WILLIE G MCELROY JR SUBDIVISION

APPLICATION NUMBER 1 DATE May 6, 2010

DETAIL SITE PLAN

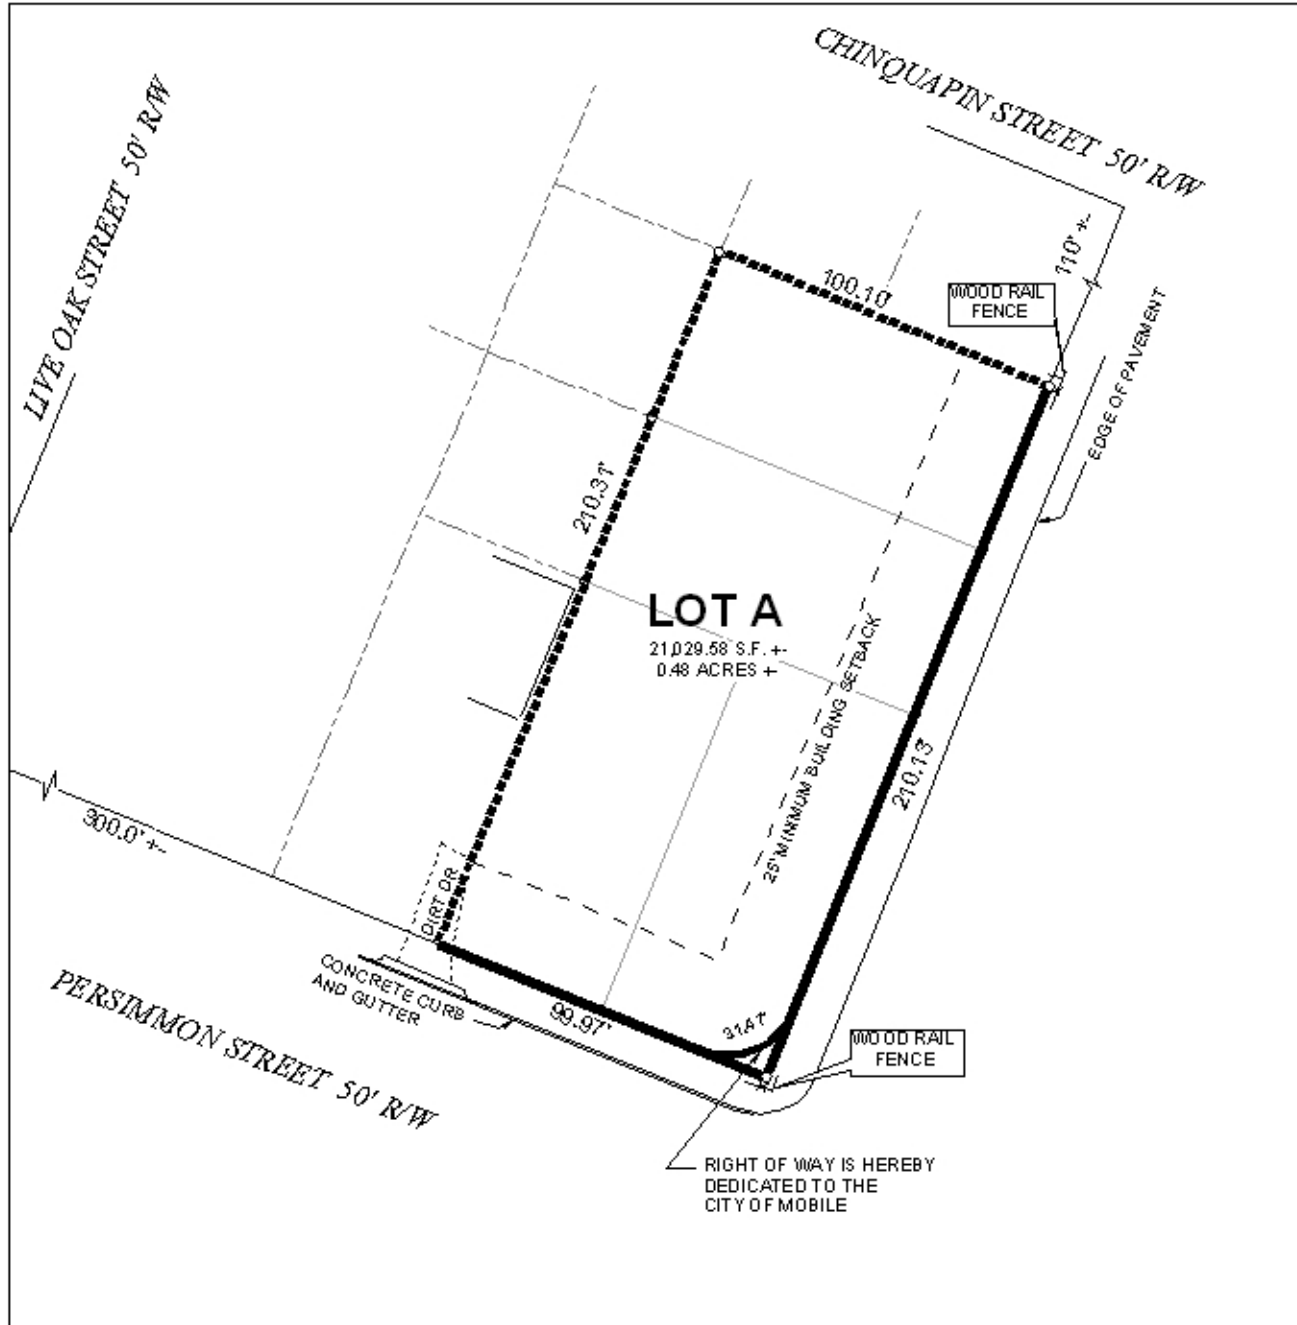
The site fronts Persimmon Street to the South and Hickory Street to the East, both minor streets with 50' of rights-of-way. It should be noted that Hickory Street does not have curb and gutter. Section V.B.14 of the Subdivision Regulations requires a minimum 60' right-of-way for streets without curb and gutter; therefore, the applicant should revise the plat to dedicate sufficient right-of-way so as to provide a minimum 30' as measured from the centerline of Hickory Street.

The site has approximately 96' and 205' of frontage along Persimmon and Hickory Streets, respectively. As a means of access management, a note should be placed on the final plat stating that the lot is limited to a maximum of one curb cut, with the size, location, and design to be approved by Traffic Engineering and in conformance with AASHTO standards.

A "wood rail" fence is illustrated both at the intersection of the two streets and at the Northeast corner of the lot. Said fence cannot be found on any past photographs of the site. The applicant is advised that, per Section 64-4.D.6 of the Zoning Ordinance, the construction of any fence that obstructs site and greater than 3' in height is prohibited within required front yards.

Instead, the applicant submitted deeds for the properties documenting that they are all either older than 1952 or have had multiple ownerships. Furthermore, with regards to dedication, the presence of curb and gutter on Persimmon and other adjacent streets may warrant a waiver of Section V.B.14 of the Subdivision Regulations. It is unlikely that Hickory Street will ever be widened; thus, additional right-of-way may be unnecessary.

- 1) placement of a note on the final plat stating that the lot is limited to a maximum of one curb cut, with the size, location, and design to be approved by Traffic Engineering and conform to AASHTO standards;*
- 2) removal of any fences erected without appropriate permits prior to signing final plat (inspection required to verify); and*
- 3) placement of a note on the plat stating that approval of all applicable Federal, state and local agencies is required for endangered, threatened or otherwise protected species, if any, prior to the issuance of any permits or land disturbance activities.*
